SOUTHERN CALIFORNIA EDISON

Pebble Beach Alternatives Study *Revised Final Action Plan*

A – SCAQMD BACT/LAER Comment Letter

Figure 1. Caterpillar Model CG260-16 Rotated Approximately 45 Degrees Counterclockwise (Left) and Approximately 40 Degrees Clockwise (Right) with Respect to Existing Unit 15's Orientation.

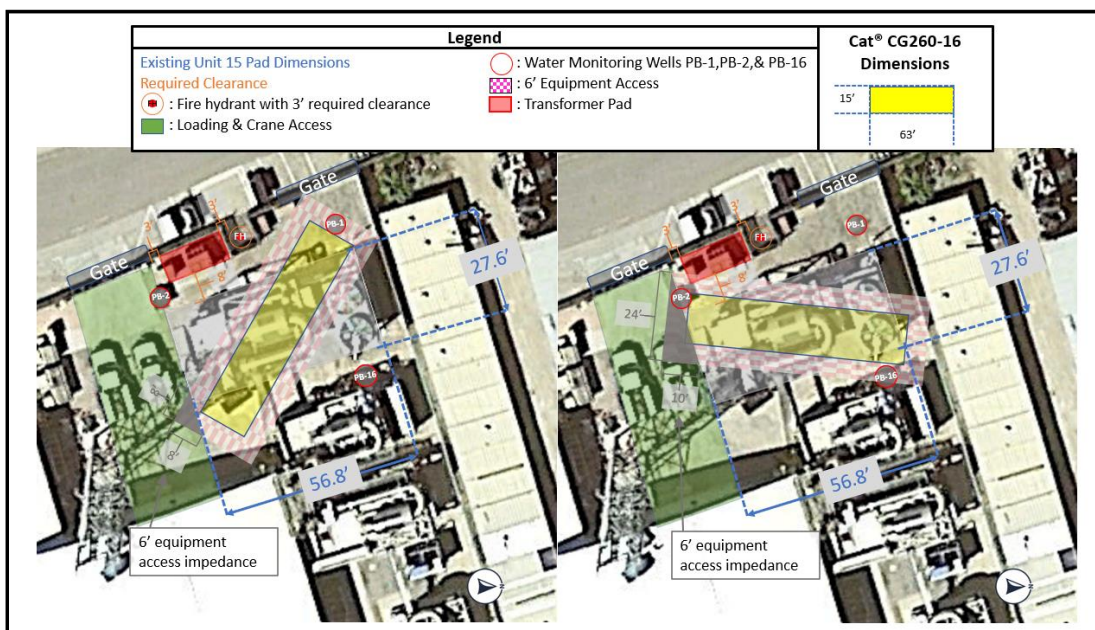
The SCAQMD's assumption that 4 feet of the 6.2-foot overhang depicted in Figure 9 represents a flashback safety clearance is incorrect. The 6.2-foot overhang is the physical space of the enclosed CG260-16 unit. SCE acknowledges that the SCAQMD's subsequent questions are based on that incorrect assumption and trusts that the aforementioned information clarifies the space issue. While it may be possible for the vendor to redesign a unit to fit the available footprint, it is simply not a viable option in the near term. Given enough time, resources, and money, a vendor may be able to design a "custom" unit for the Catalina space. However, SCE has learned through the Request for Proposals process that any equipment other than "off the shelf" options will take an additional four to five years to procure. In other words, if SCE is the only market, and the product cannot be scaled, years are added to the process. This is something SCE could have pursued

As shown in Figure 1, rotating the 4-MW Caterpillar CG260-16 roughly 45 degrees counterclockwise or 40 degrees clockwise with respect to the existing Unit 15 yields a configuration that appears to physically fit the space. However, the required clearances for the transformer pad and designated area for loading and crane access would be impeded. Additionally, the proposed orientation would cover a water monitoring well (PB-2). Moving the well would delay the project because: (1) SCE would need to coordinate with the Los Angeles Regional Water Quality Control Board for approval of the relocation or abandonment of the monitoring well; and (2) significant time would be required to pull the required permits for the installation of a new well and/or destruction of the existing well.

In summary, SCE has provided Figure 1 solely to respond to the SCAQMD's question. However, SCE does not recommend a diagonal configuration and trusts that Figure 1 and the above discussion convey why this is not an acceptable option for PBGS.
